Urban Design Review of Planning Proposal

642 - 644 Canterbury Road

June 2015

Annand Associates Urban Design

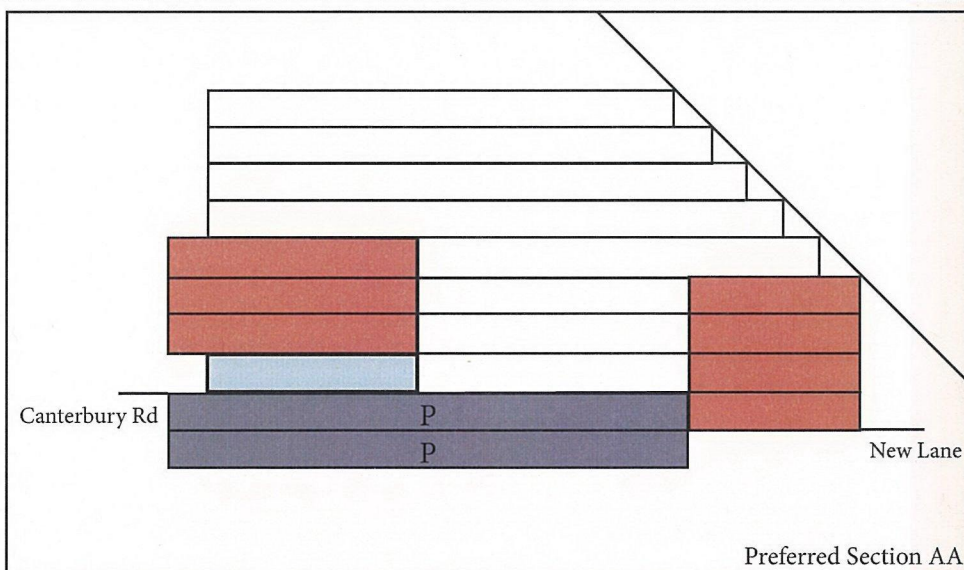
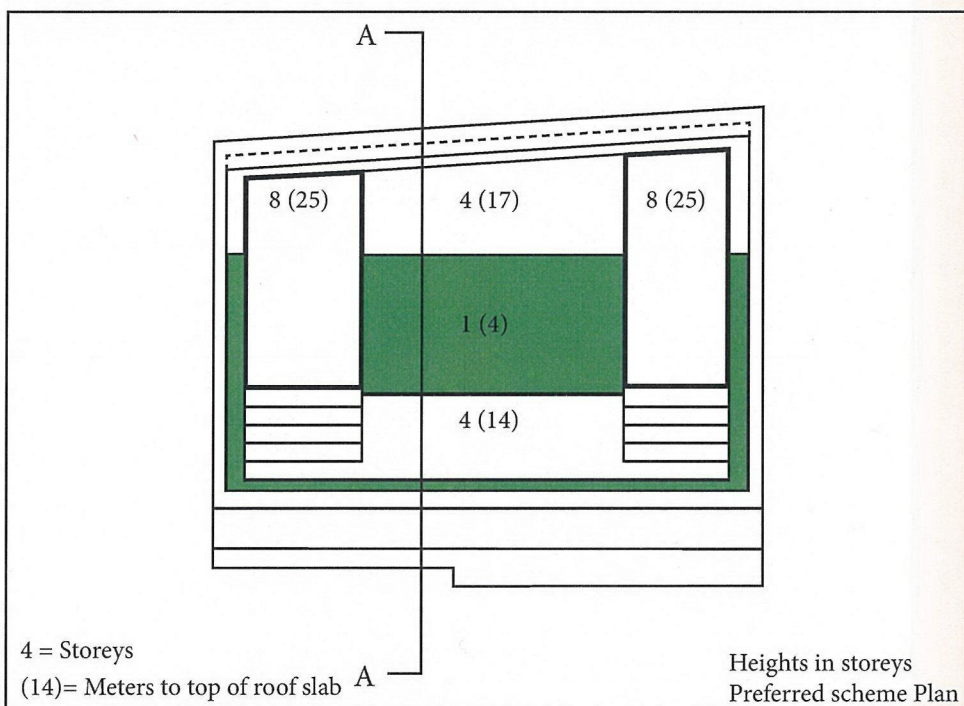
The proponents have made a case for the re-allocation of floor space from the Canterbury Road frontage into two towers fronting Canterbury Road (but also Liberty street and Platts Ave) of 8 storeys (Their drawings however show 10 storeys).

Whilst generally sympathetic with this solution ,however we are unconvinced of the need to increase the towers to 30m and particularly to 10 storeys.

This will be excessive in the context of existing and future Canterbury Road Framework (8 storey nodes and 3-6 storey between). We would suggest 8 storey maximum which could be 25m. in height (to top of the roof slab)

2. Rezone the subject site from B6 to B5 (Business Development)
3. Permit modified height limits as set out below permitting development to a maximum of 8 storeys/ 25m (see attached plan).

4. Balance the floor space increase (additional height to 8 storeys), with reduction in central block Canterbury Road frontage (4 -5 storeys).
5. Provide (and dedicate to Council) the rear lane connecting Platts Ave and Liberty street.
